Technical Service Bulletin WSB-14 Repair Instructions

Purpose: Update the electrical system for Open Trail Motorhomes with a 51-volt system.

Models: 2025 & 2026 Open Trail Motorhomes

Figure 1A

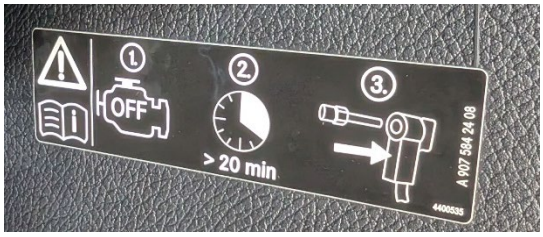
1. Turn off all power to coach.
   - Disconnect the shore power cord from coach.
   - Turn off the battery disconnect switch found in the step well and power off lighted blue LED battery switch
   - Disconnect chassis battery at the battery disconnect by removing the access panel next to the accelerator pedal. Push in red or black tab and disconnect. NOTE: Wait 20 minutes after turning engine off to avoid any unintentional short circuit or engine warning lights. See Figure 1A and 1B.

Figure 1a - Original Inverter

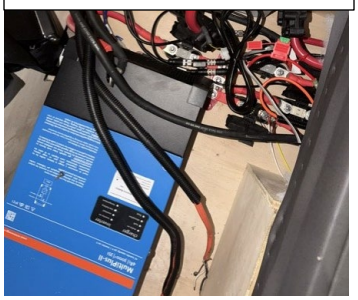
3. Remove the old inverter from coach, see figure 1a.
   - Remove cover from inverter to access cable connections
   - Disconnect 10-2 wires
   - Disconnect ground and positive cable connections.

- Remove screws that secure inverter to floor of the electrical box.
   - Discard old inverter.
4. Install new Inverter, part #5177575, figure 1b, pre-programmed inverter

- Remove covers from new inverter.
   - Install the previously removed 10-2 wires, being sure to verify the labeling on the wire to correctly hook up the inverter in and inverter out wires.

- Route the 10-2 wire through the rubber grommets and clamps, secure clamps but do not overtighten.
   - Reinstall ground and positive cables to the corresponding lug on new inverter

- Secure the base of the new inverter to the battery box and reinstall the cover over the wiring connections.
   - Ground the inverter by installing a ground cable from inverter to the ground buss bar.

Figure 4

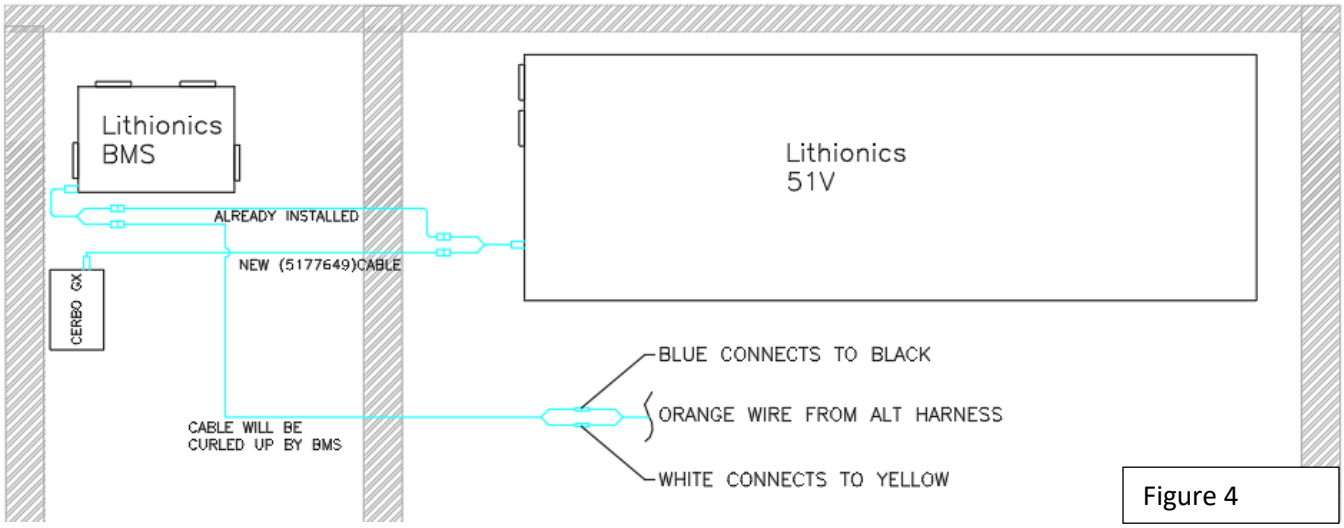
1. Install part # 5177649 from the battery harness to the Victron Cerbo.
2. Connect BMS communication cable from BSM to orange wire from alternator harness (located in battery box). See diagram, figure 4.

Figure 7

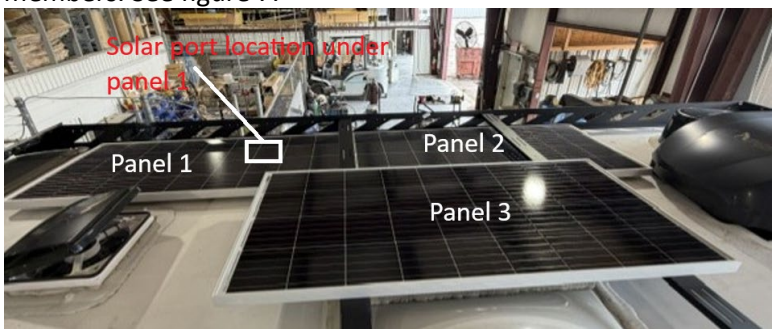
7. Mount new solar panel, part # 5134887, using bracket parts # 5159607, to secure roof rack cross members. See figure 7.

Figure 8

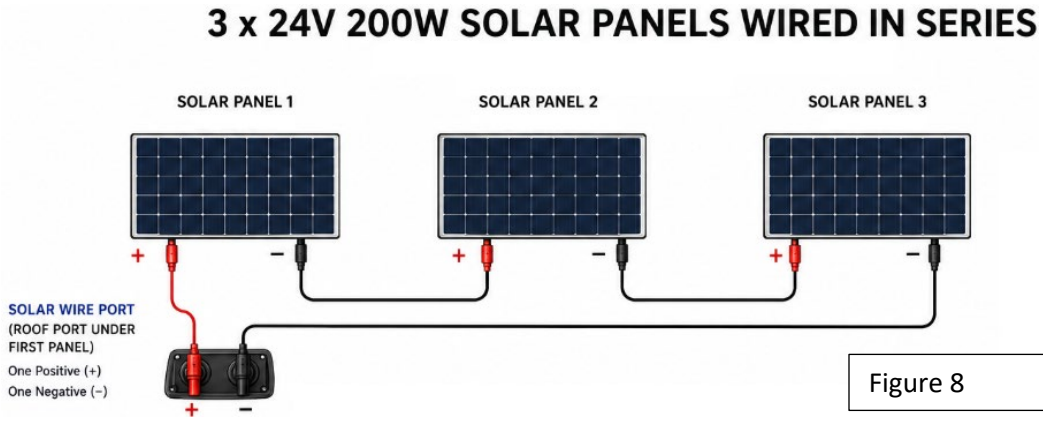
8. Use part # 5113954 to connect the new panel to the existing panels.
9. Remove panel 1 and panel 2 mounting brackets from the roof on the PS of the unit. This will allow access to underneath the solar panels cable connections.
10. Verify the wiring on all solar panels to be wired in series, NOT in parallel. See figure 8.

11. Once all 3 panels are connected and wired in series, use White CSL to resecure all solar panel brackets to the roof.
12. Remove existing Lithionics solar controller.
13. Install the Victron Solar controller, part # 5178094.
14. Install harness/cable # 5163250, to connect the solar controller to the Cerbo.

Transfer Switch Wiring (only on Gen units)

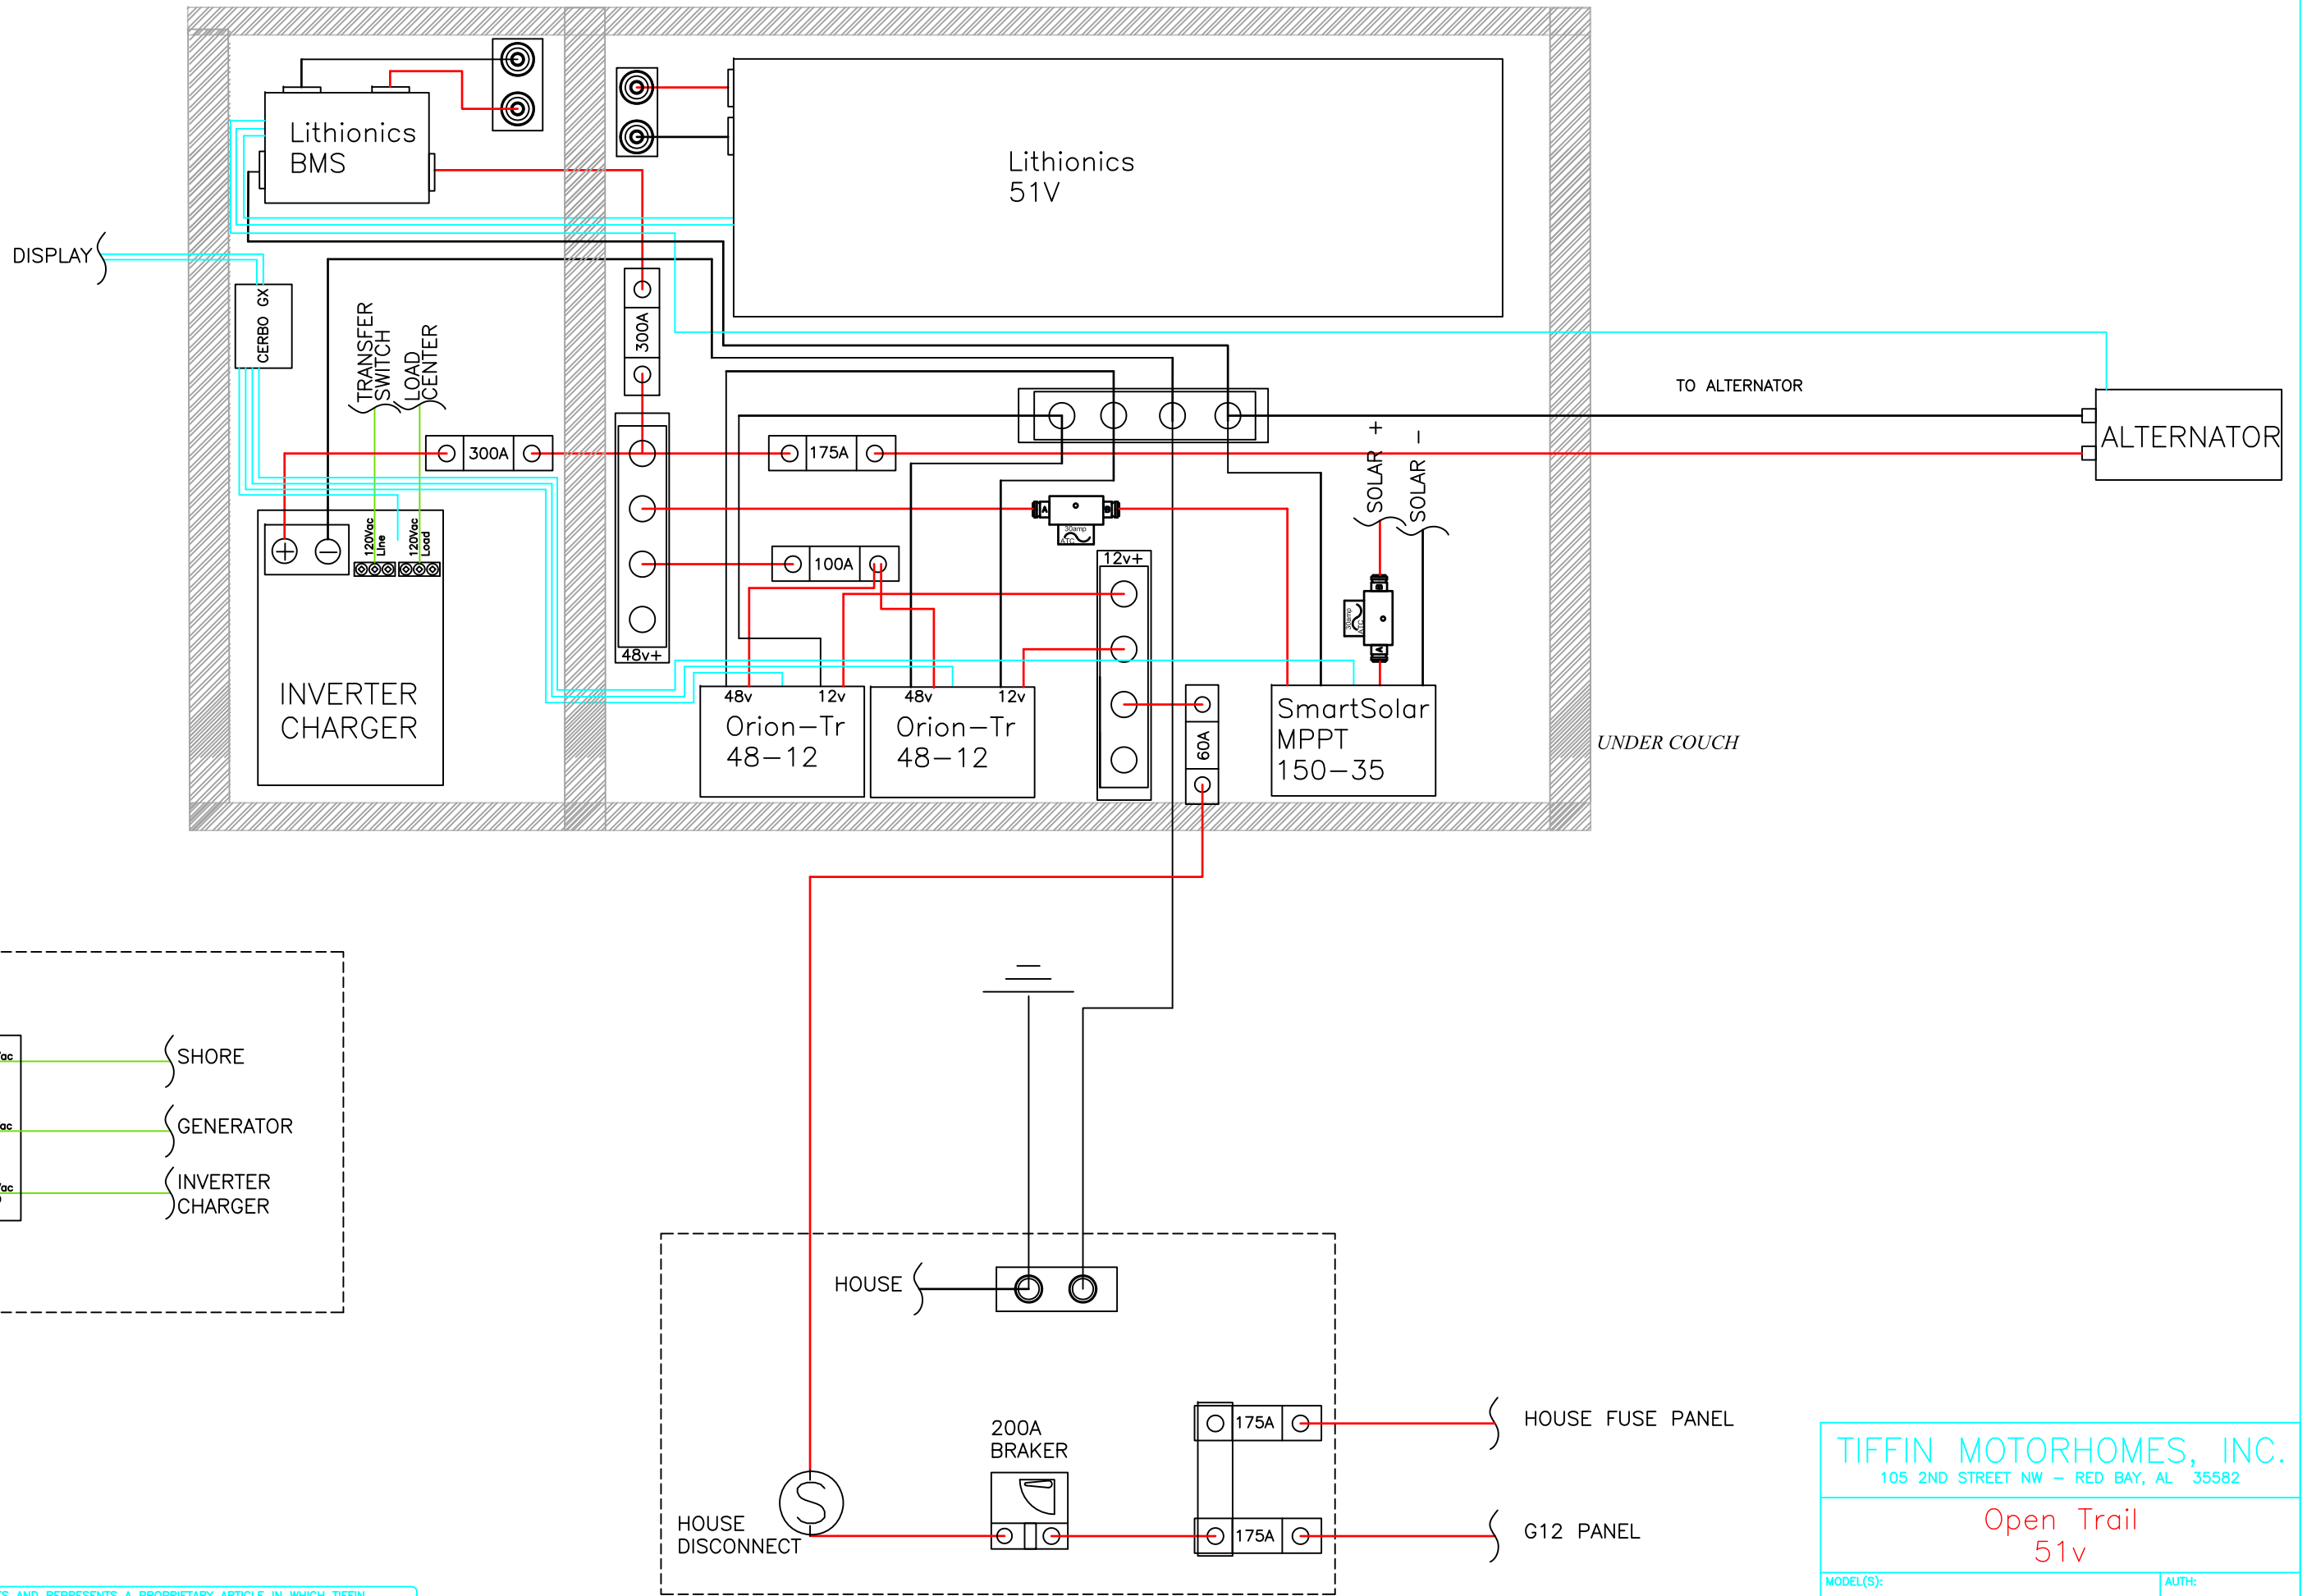
20. Verify the wiring from the shore power to the inverter.
    - Connect shore power cord to the motorhome but **DO NOT** plug into the power outlet.

- Check for continuity on the house harness labeled inverter in
    - If continuity is present, the transfer switch must be rewired by following the next step.

21. Correct wiring on transfer switch
    - Top breaker on shore power is the inverter out circuit.
    - Pull out of transfer switch and on the output side of the transfer switch should be the wire feeding the breaker box.

- Those need to be tied together in a sealed junction box, part # 5035742, with wago connectors, part # 5085443.
    - The wire from the smart plug(shore power) is the inverter in circuit.

- That needs to be moved to the output side of the transfer switch.
    - Run a new wire from the smart plug to be connected to the top breaker on the input side of the transfer switch should be labeled shore power on the transfer switch cover.

22. Verify by plugging in the shore/smart cord and the top breaker should latch.
